Economic Commission for Europe**Inland Transport Committee****World Forum for Harmonization of Vehicle Regulations****Working Party on Lighting and Light-Signalling****Eighty-first session**

Simplification of lighting and light-signalling UN Regulations**Proposal for a new [07] series of amendments to UN
Regulation No. 48 (Installation of lighting and light-signalling
devices)****Submitted by the Informal Working Group on Simplification of
Lighting and Light-Signalling Regulations (IWG SLR)***

The above limits and the initial aiming values are summarized in the diagram below.

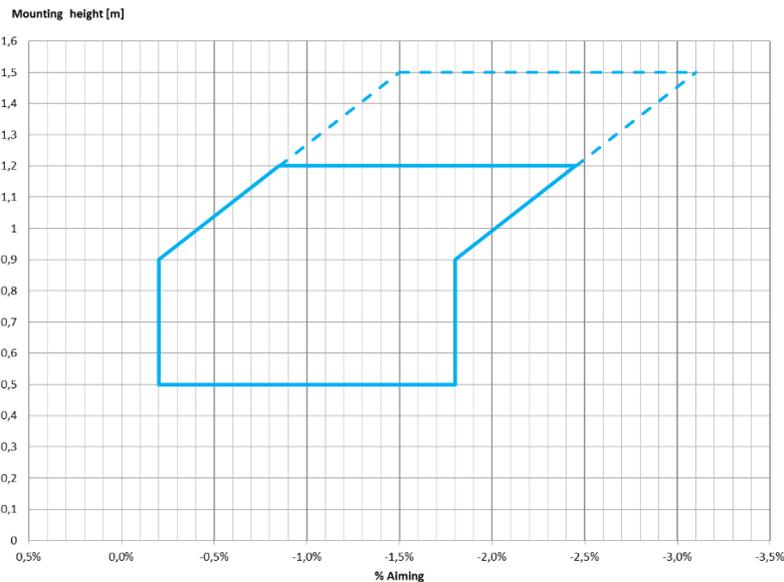
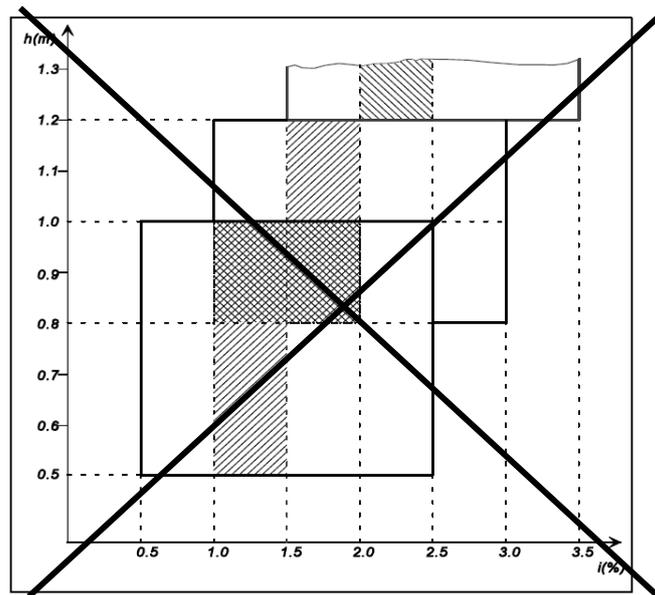
- 6.2.6.1.2. Depending on the mounting height in metres (h) of the lower edge of the apparent surface in the direction of the reference axis of the dipped-beam headlamp, measured on the unladen vehicles, the vertical inclination of the cut-off of the dipped beam, **starting from the initial inclination value set by the vehicle manufacturer as prescribed in paragraph 6.2.6.1.1. above**, shall ~~under all the static conditions of Annex 5~~, remain between the following limits, **under all the stating loading conditions of Annex 5**:

- for $0.5\text{ m} < h < 0.9\text{ m}$, between:**
-0.2 % and -1.8 %;
- for $0.9\text{ m} < h < 1.2\text{ m}$, between:**
the minimum vertical inclination limit increasing linearly, in relation to the dipped-beam headlamp mounting height, from - 0.2 % to - 0.8[5] %
and
the maximum vertical inclination limit increasing linearly, in relation to the dipped-beam headlamp mounting height,

from - 1.8 % to - 2.4[5] %;

[For In the case of category N₃G (off-road) vehicles: , where the headlamps exceed a height of 1,200 mm the limits for the vertical inclination of the cut off shall be between: 1.5 per cent and 3.5 per cent for 1.2 m < h < 1.5 m, between:

the minimum vertical inclination limit increasing linearly, in relation to the dipped-beam headlamp mounting height, from - 0.8[5] % to - 1.5 %

the maximum vertical inclination limit increasing linearly, in relation to the dipped-beam headlamp mounting height, from - 2.4[5] % to - 3.1 %.]

10. The range of vertical orientation has been modified based on the IWG VGL decisions. IWG VGL decided to present a proposal in which this range is from 0% to -1.6 %; it was also agreed that, if requested by GRE Experts, the 0 % limit will be moved to the -0.2 % limit maintaining the 1.6 % range (i.e. shifting in parallel the upper limit to -1.8 %). The United Kingdom of Great Britain and Northern Ireland (UK) and Poland requested the International Organization of Motor Vehicle Manufacturers (OICA) to provide better justifications for the need to have a range at least 1.6 % wide.

11. At the seventy-eighth session of GRE, some experts requested to shift the 0 % limit to -0.2 % and nobody opposed the parallel shifting of the -1.6 % limit to -1.8 % limit. UK and Poland reiterated their request for better justification for the need to have a range at least 1.6 % wide.

12. As far as the range of vertical orientation for N3G category vehicles having headlamps installed at more than 1.2 m from the ground is concerned, IWG VGL did not take any decision, even if the idea to follow the same parameters used for the other vehicles categories was discussed. The proposed values are then put in square brackets; in any case they provide an improvement, from illumination distance point of view, in respect to the present requirements.

13. Finally, among the proposed orientation limit values, two of them should have, from calculation, two digits after the coma, while only one digit after the coma is indicated in the present text of UN Regulation No. 48. Consequently, the second digit is always indicated in square brackets, to decide whether to maintain it or round the first digit to the nearest value.

Model A

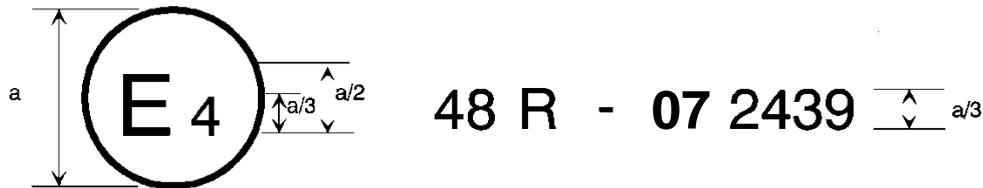
The above approval mark affixed to a vehicle shows that the vehicle type concerned has, with regard to the installation of lighting and light-signalling devices, been approved in the Netherlands (E 4) pursuant to Regulation No. 48 as amended by the ~~06~~ [07] series of amendments. The approval number indicates that the approval was granted in accordance with the requirements of Regulation No. 48 as amended by the ~~06~~ [07] series of amendments.

19. This annex is amended to update the marking examples and related description to the introduction of the 07 series of amendments.

Model B

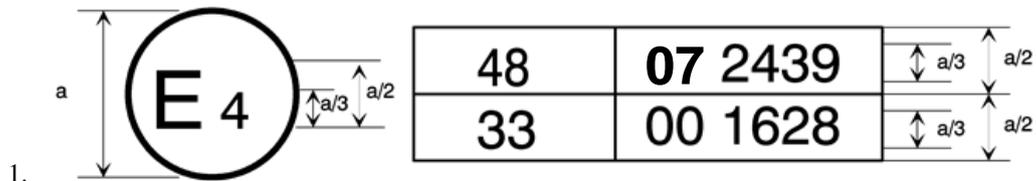
The above approval mark affixed to a vehicle shows that the vehicle type concerned has been approved in the Netherlands (E 4) pursuant to Regulation No. 48 as

amended by the 06 [07] series of amendments and Regulation No. 33.^[1] The approval number indicates that, at the dates when the respective approvals were given, Regulation No. 48 was amended by the 06 [07] series of amendments and Regulation No. 33 was still in its original form.
